City of Puyallu Development Engineering APPROVED

- A. STREET ADDRESS 300 RIVER ROAD, PUTALLUP, WA 98371
- B. PARCEL NUMBER(S) 0420214010, 0420214027 & 0420281154
- C. PROPERTY AREA 3.054 ACRES

- A. APPLICABLE CODE 2018 INTERNATIONAL BUILDING CODE 2018 WA STATE ENERGY CODE AS APPLICABLE TO THE PROPOSED ADDITION
- B USE **AUTOMOTIVE SALES & SERVICE**
- C. CONSTRUCTION TYPE TYPE V-B, NON-SEPARATED USES

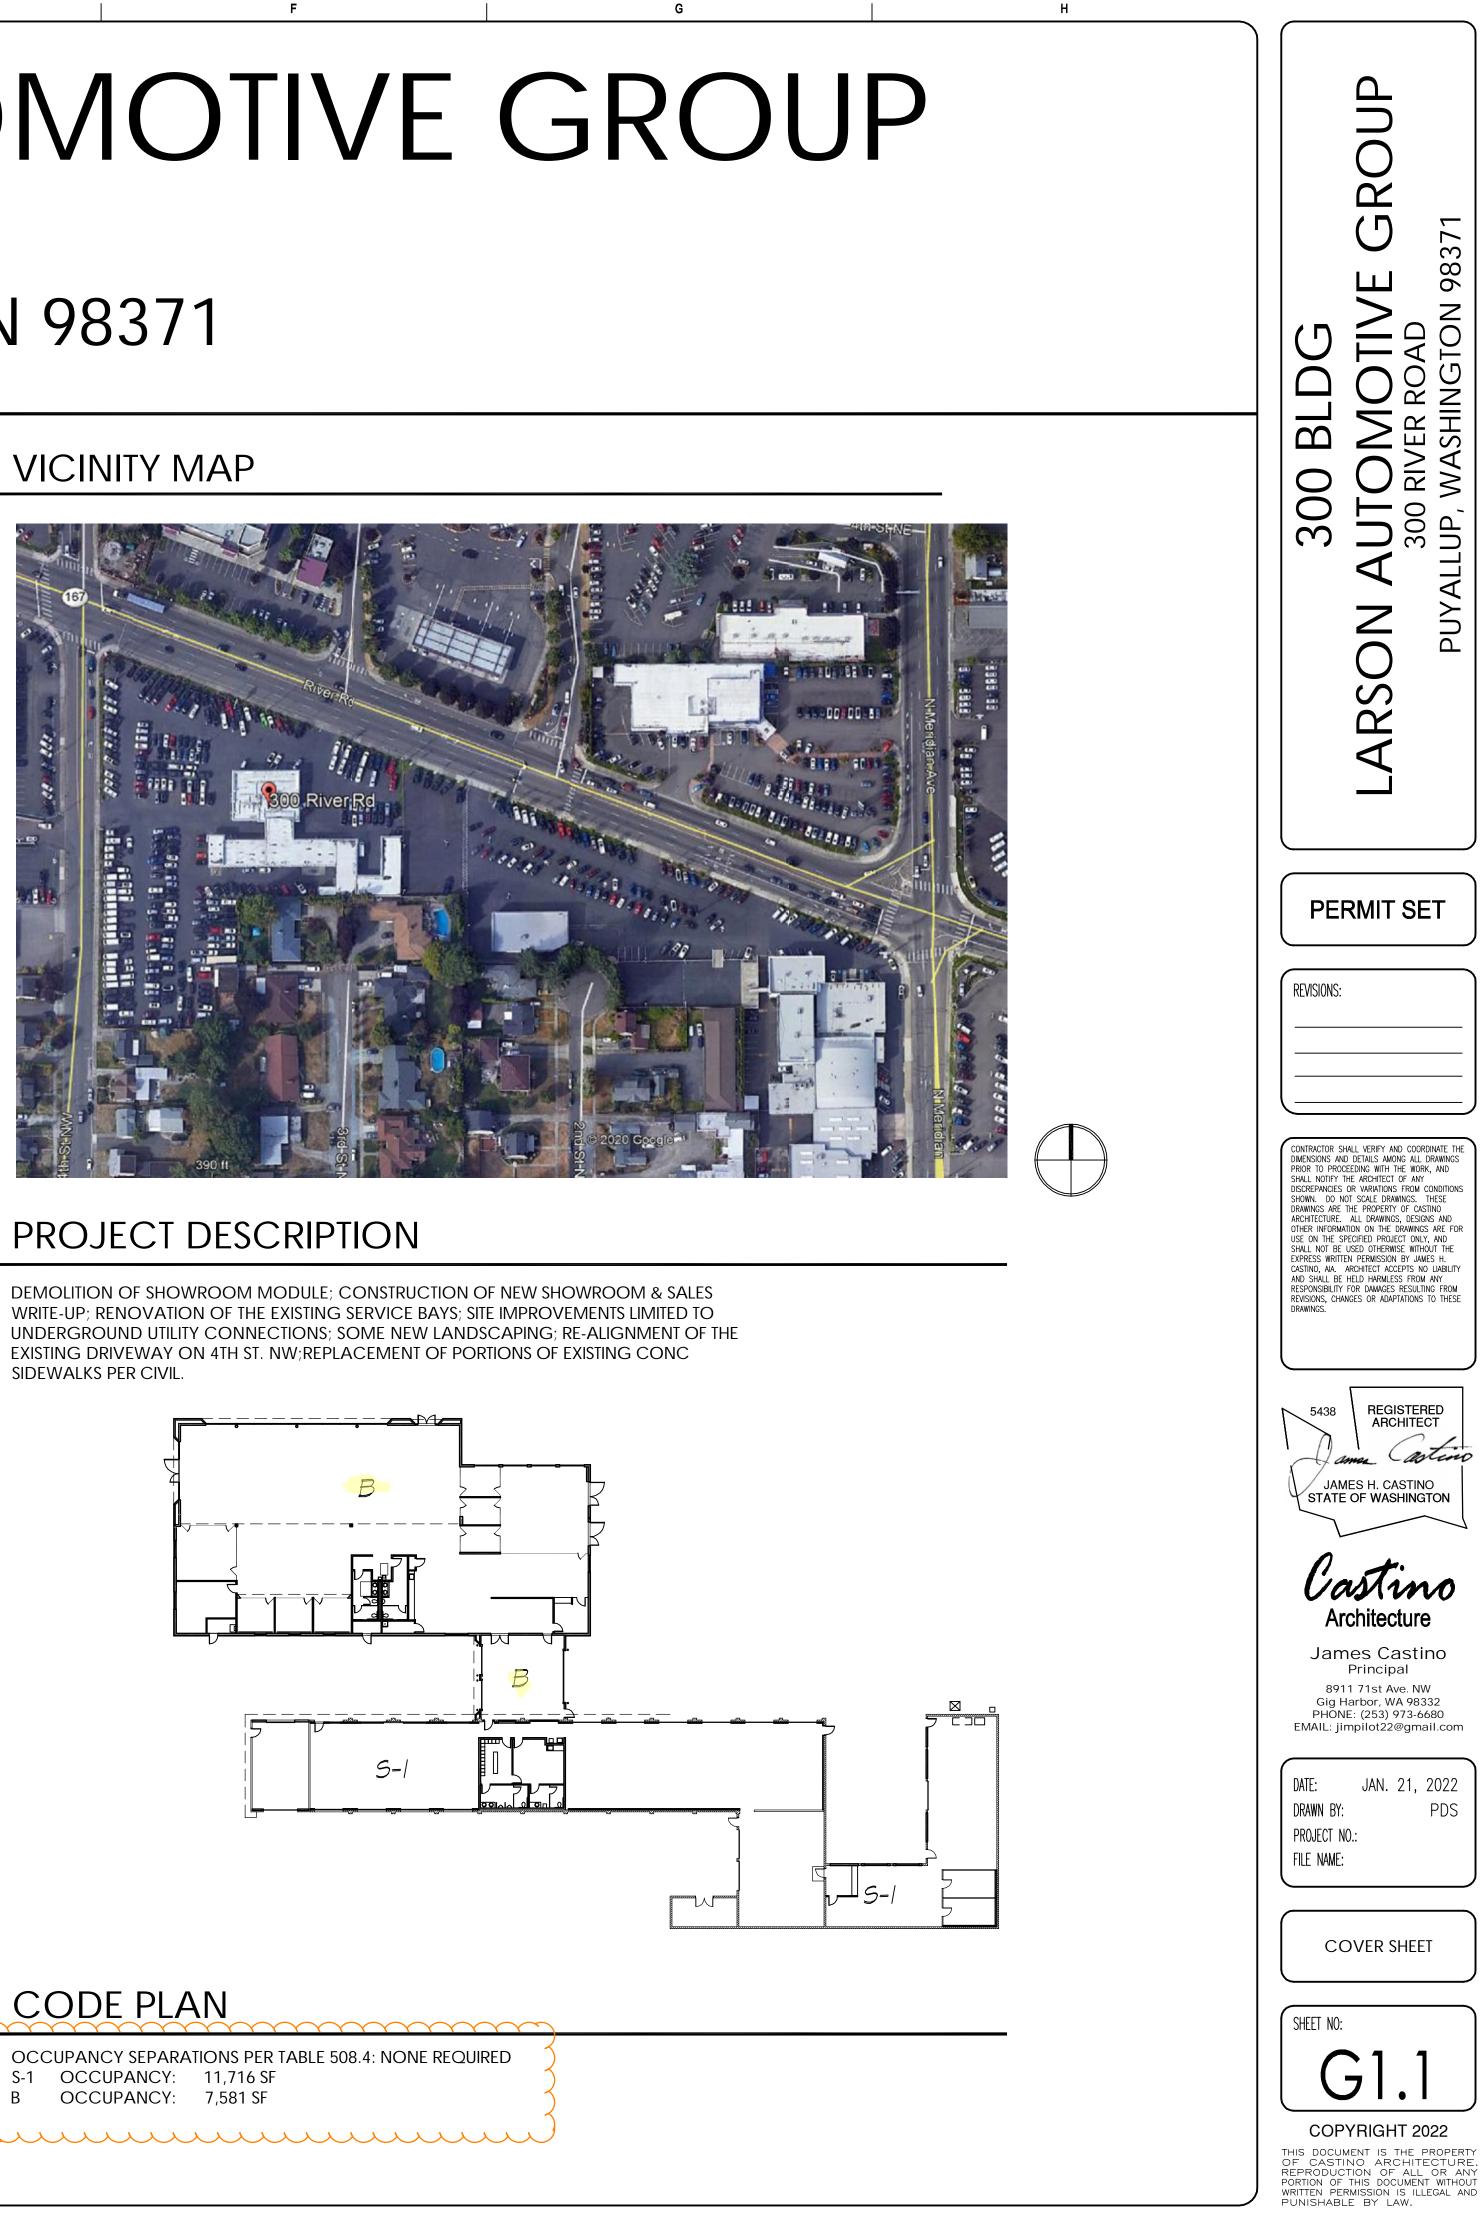
G1.1 - CODE PLAN NOTES B OCCUPANCY TYPE M,

REVISE TO CORRECT OCCUPANCY TYPE.

REFERENCE NO. **C1.0**

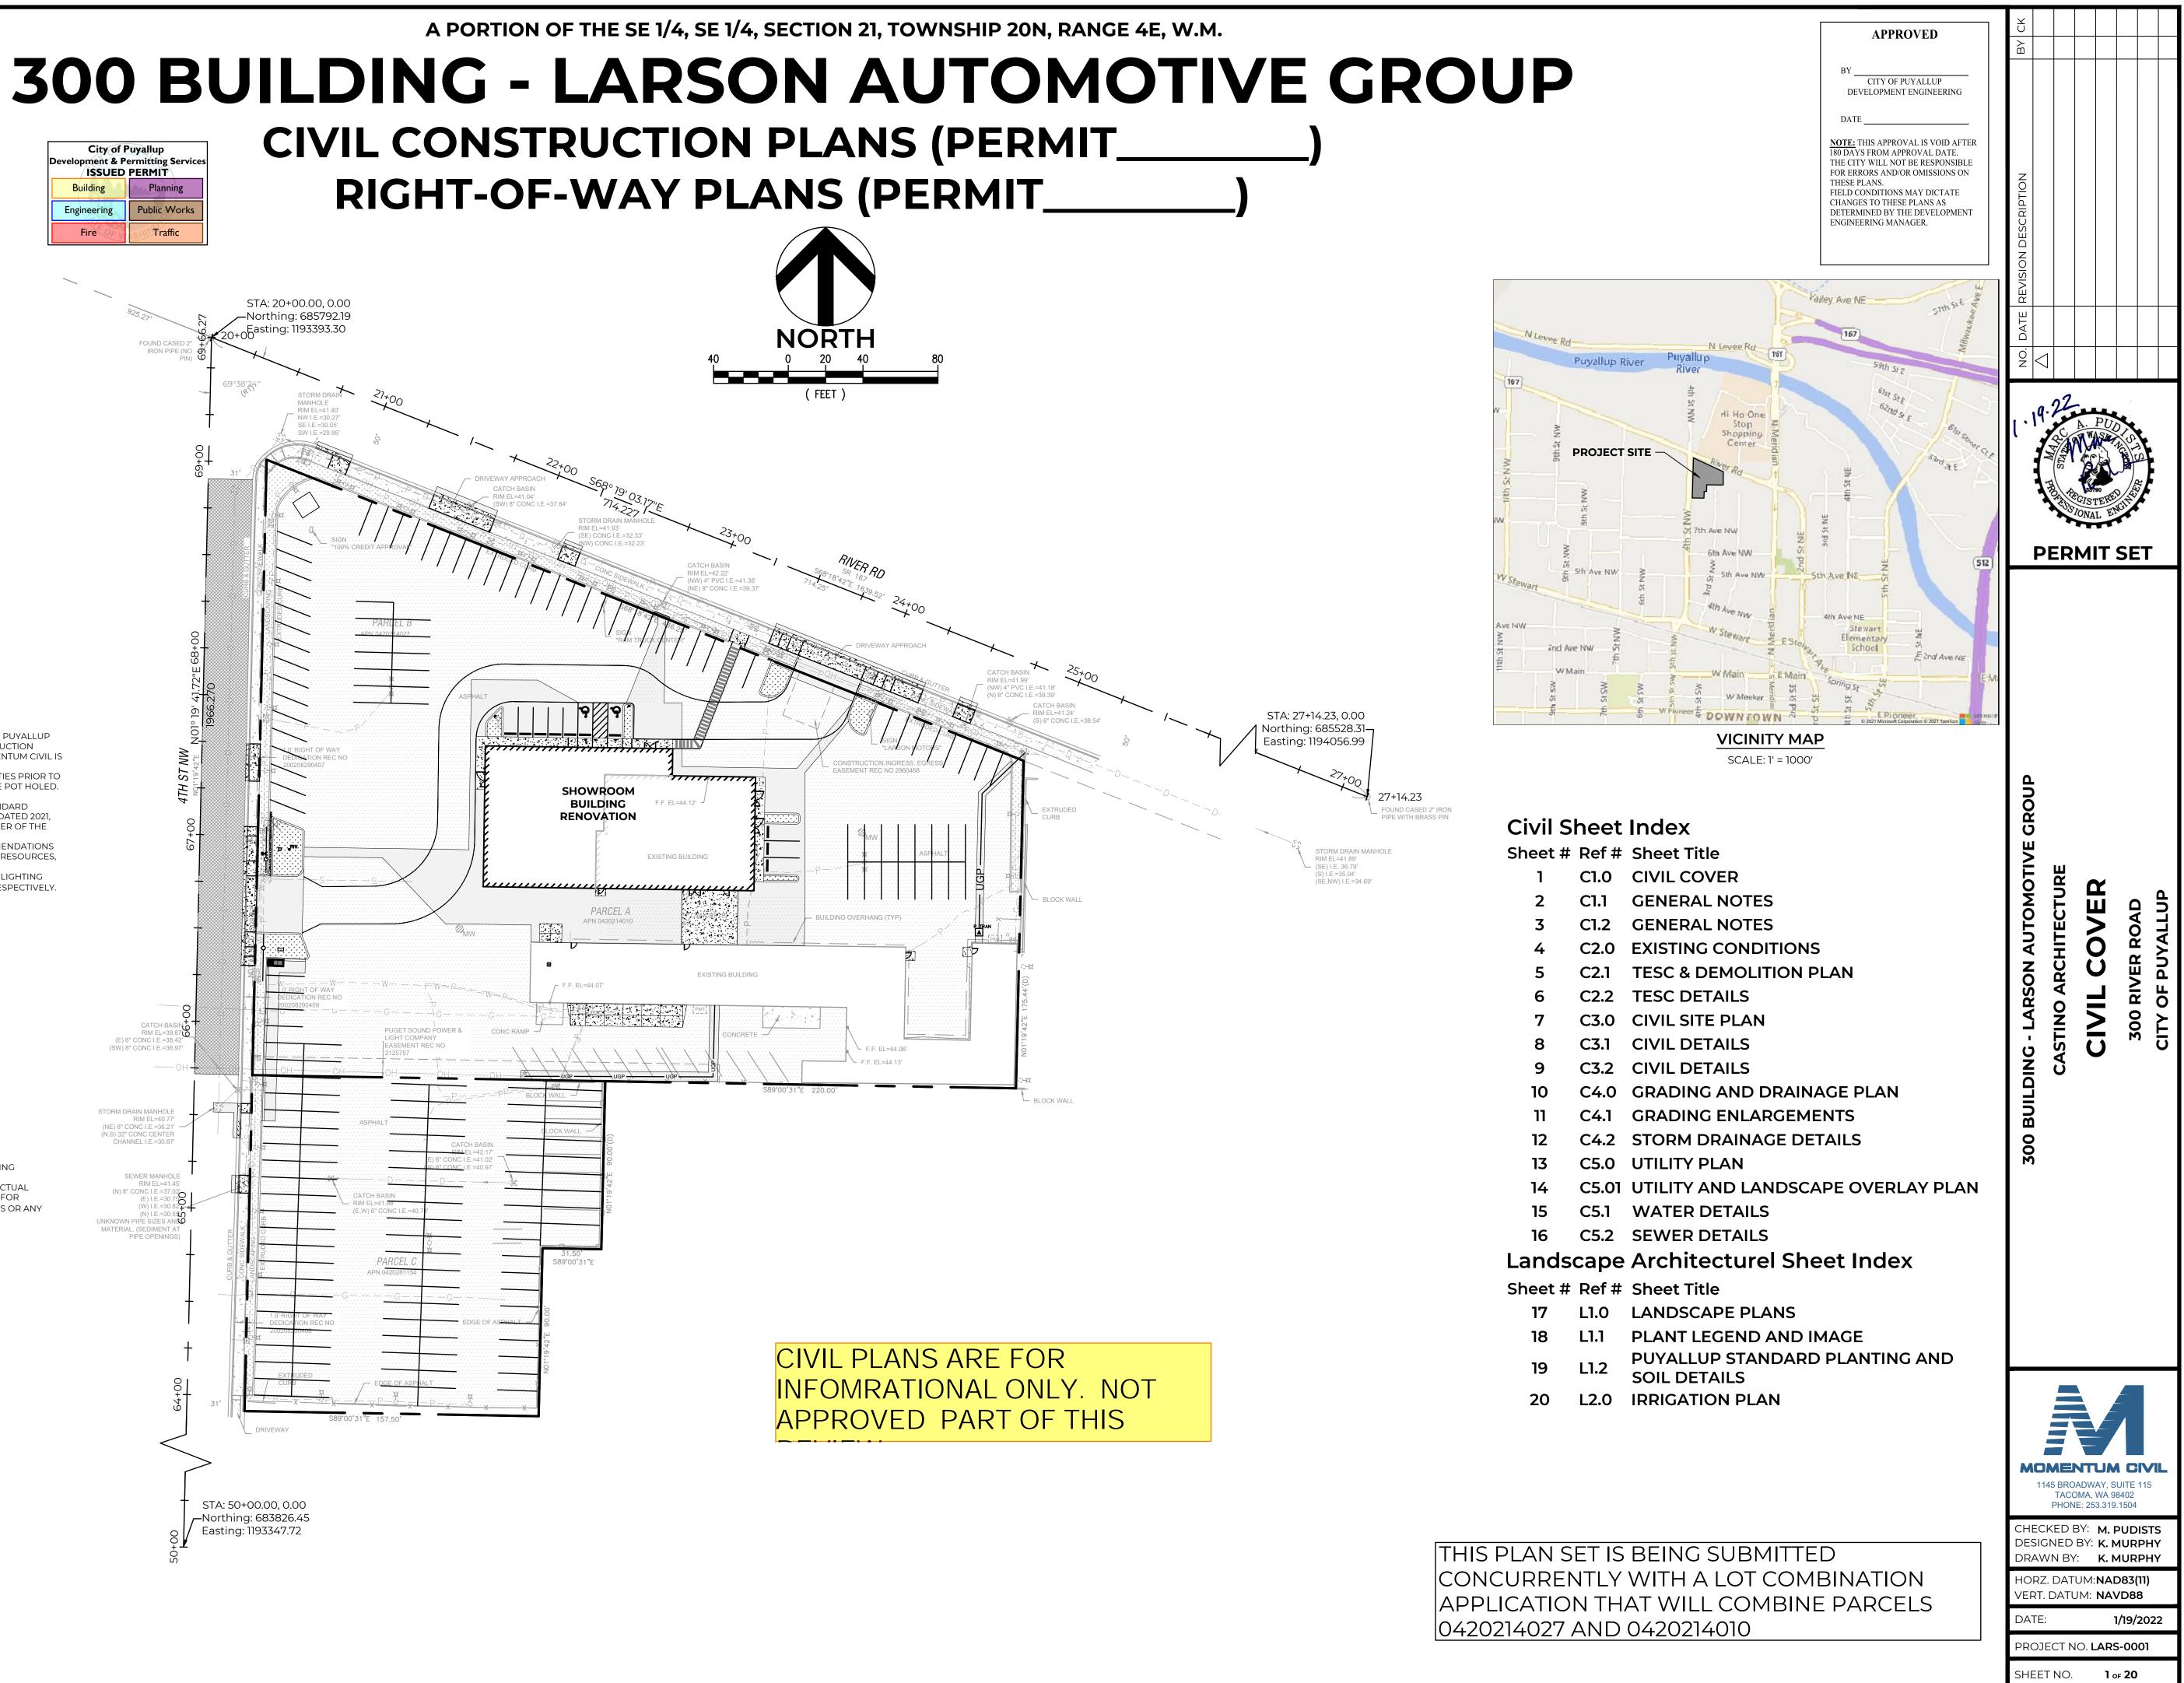
efer to approved civil plan: for sedimentation and erosion control methods Refer to approved civil plan: PRCCP20220092 for roof downspout control methods

This project type requires a properly All commercial development water sized oil-water separator is installed and services must have approved backflow that it is sized correctly and maintained prevention assembly to protect the in accordance with Puyallup Municipal public potable water suppy. See PMC Code Chapter 14.06.031 (5).

14.02.220(3)
